WORKING GROUP REPORT

Power Park Modules and Synchronous Generating Units Working Group

Reference	PPMSGUWG Report
Issue	1.0
Date of Issue	9 th November 2006
Prepared by	PPMSGUWG

Figure CC.A.7.2.2a

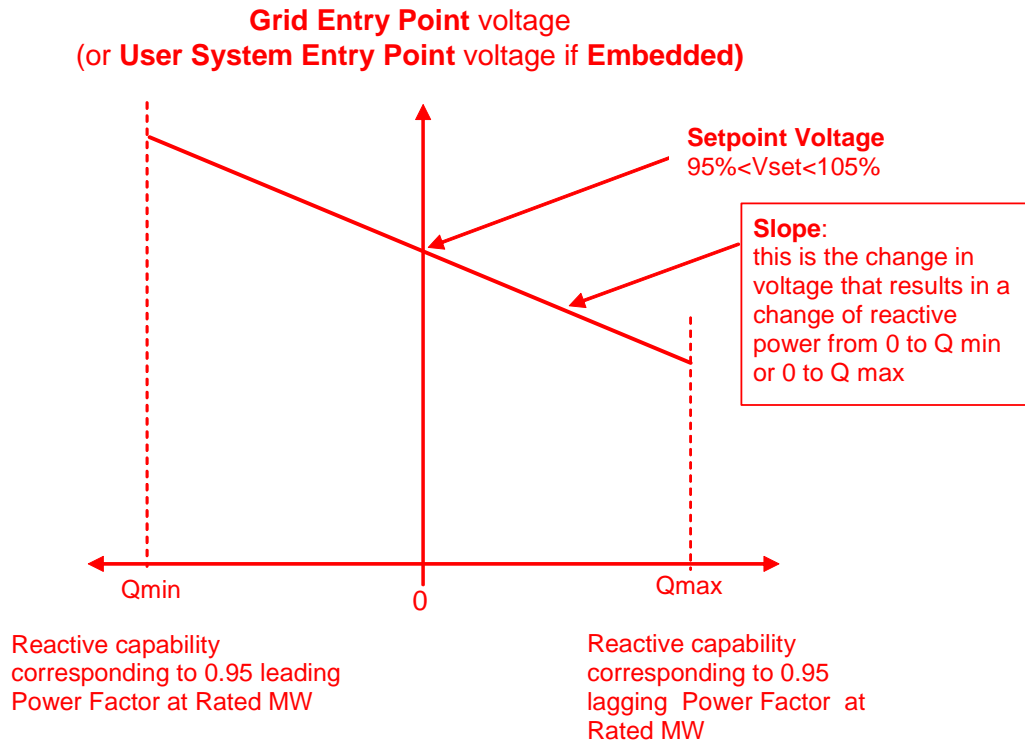
CC.A.7.2.2.1 The **Non-Synchronous Generating Unit, DC Converter or Power Park Module** shall provide continuous steady state control of the voltage at the **Grid Entry Point** (or **User System Entry Point** if **Embedded**) with a **Setpoint Voltage** and **Slope** characteristic as illustrated in Figure CC.A.7.2.2a.

- CC.A.7.2.2.5 Should the operating point of the **Non-Synchronous Generating Unit, DC Converter or Power Park Module** deviate so that it is no longer a point on the operating characteristic (figure CC.A.7.2.2a) defined by the target **Setpoint Voltage** and **Slope**, the continuously acting automatic voltage control system shall act progressively to return the value to a point on the required characteristic within 5 seconds.

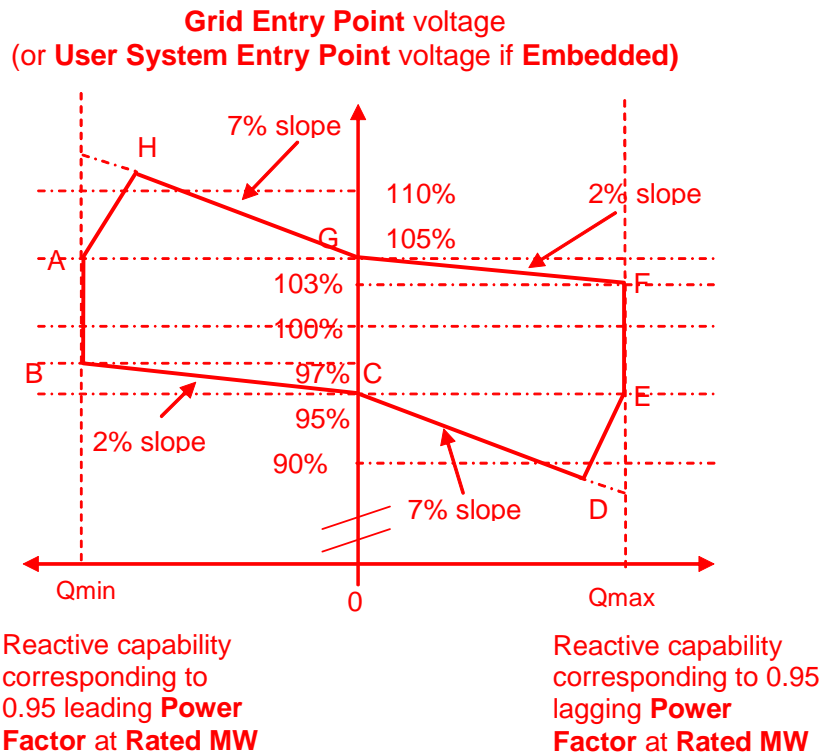
- CC.A.7.2.2.4 Figure CC.A.7.2.2b shows the required envelope of operation. The enclosed area within points ABCDEFGH is the required capability range of the **Non-Synchronous Generating Unit, DC Converter or Power Park Module** within which the **Slope** and **Setpoint Voltage** can be changed.

- CC.A.7.2.2.6 Should the **Reactive Power** output of the **Non-Synchronous Generating Unit, DC Converter or Power Park Module** reach its maximum lagging limit at a **Grid Entry Point voltage** (or **User System Entry Point voltage** if **Embedded**) above 95%, the **Non-Synchronous Generating Unit, DC Converter or Power Park Module** shall maintain maximum lagging **Reactive Power** output for voltage reductions down to 95%. This requirement is indicated by the line EF in figure CC.A.7.2.2b. Should the **Reactive Power** output of the **Non-Synchronous Generating Unit, DC Converter or Power Park Module** reach its maximum leading limit at a **Grid Entry Point voltage** (or **User System Entry Point voltage** if **Embedded**) below 105%, the **Non-Synchronous Generating Unit, DC Converter or Power Park Module** shall maintain maximum leading **Reactive Power** output for voltage increases up to 105%. This requirement is indicated by the line AB in figure CC.A.7.2.2b.

from the supply of maximum lagging reactive current whilst ensuring the current remains within design operating limits. An example of the capability is shown by the line DE in figure CC.A.7.2.2b. For **Grid Entry Point** voltages (or **User System Entry Point** voltages if **Embedded**) above 105%, the leading **Reactive Power** capability of the **Non-Synchronous Generating Unit, DC Converter or Power Park Module** should be that which results from the supply of maximum leading reactive current whilst ensuring the current remains within design operating limits. An example of the capability is shown by the line AH in figure CC.A.7.2.2b. Should the **Reactive Power** output of the **Non-Synchronous Generating Unit, DC Converter or Power Park Module** reach its maximum lagging limit at a **Grid Entry Point** voltage (or **User System Entry Point** voltage if **Embedded**) below 95%, the **Non-Synchronous Generating Unit, DC Converter or Power Park Module** shall maintain maximum lagging reactive current output for further voltage decreases. Should the **Reactive Power** output of the **Non-Synchronous Generating Unit, DC Converter or Power Park Module** reach its maximum leading limit at a **Grid Entry Point** voltage (or **User System Entry Point** voltage if **Embedded**) above 105%, the **Non-Synchronous Generating Unit, DC Converter or Power Park Module** shall maintain maximum leading **Reactive Power** output for further voltage increases.

Figure CC.A.3.2 - Interpretation of Primary and Secondary Response Values

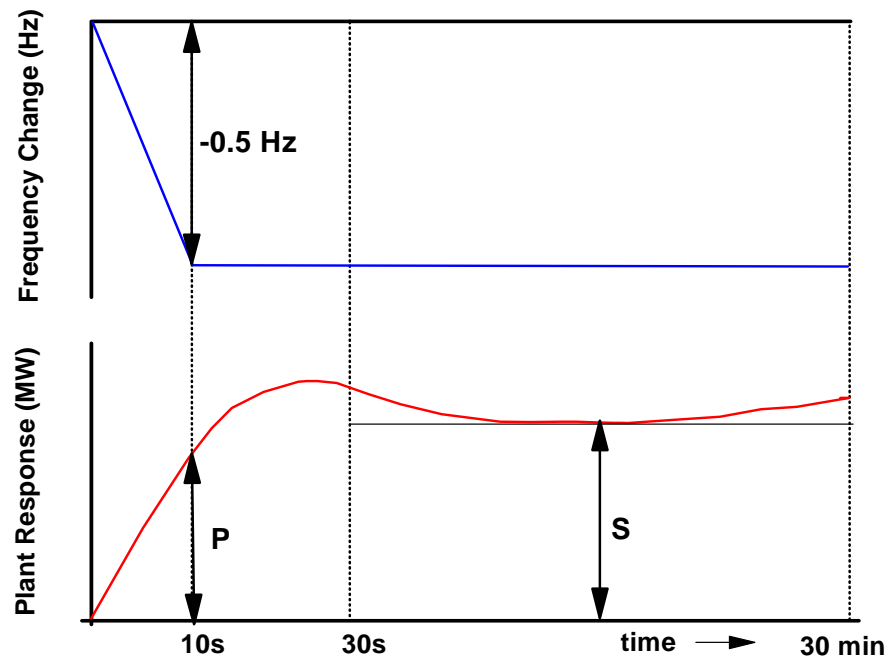
The **Primary Response** capability (P) of a **Generating Unit** or a **CCGT Module** or **Power Park Module** or **DC Converter** is the minimum increase in **Active Power** output between 10 and 30 seconds after the start of the ramp injection as illustrated diagrammatically in Figure CC.A.3.2. This increase in Active Power output should be released increasingly with time over the period 0 to 10 seconds from the time of the start of the Frequency fall as illustrated by the response in Figure CC.A.3.2.

The **Secondary Response** capability (S) of a **Generating Unit** or a **CCGT Module** or **Power Park Module** or **DC Converter** is the minimum increase in **Active Power** output between 30 seconds and 30 minutes after the start of the ramp injection as illustrated diagrammatically in Figure CC.A.3.2.

Figure CC.A.3.3 - Interpretation of High Frequency Response Values

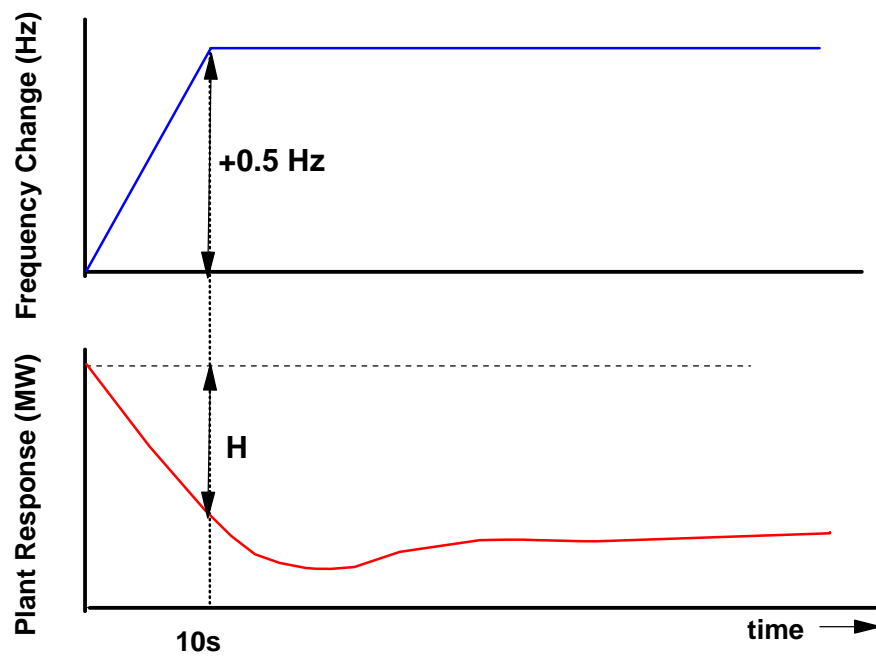
The **High Frequency Response** capability (H) of a **Generating Unit** or a **CCGT Module** or **Power Park Module** or **DC Converter** is the decrease in **Active Power** output provided 10 seconds after the start of the ramp injection and

sustained thereafter as illustrated diagrammatically in Figure CC.A.3.3. This reduction in **Active Power** output should be released increasingly with time over the period 0 to 10 seconds from the time of the start of the **Frequency** rise as illustrated by the response in Figure CC.A.3.2.
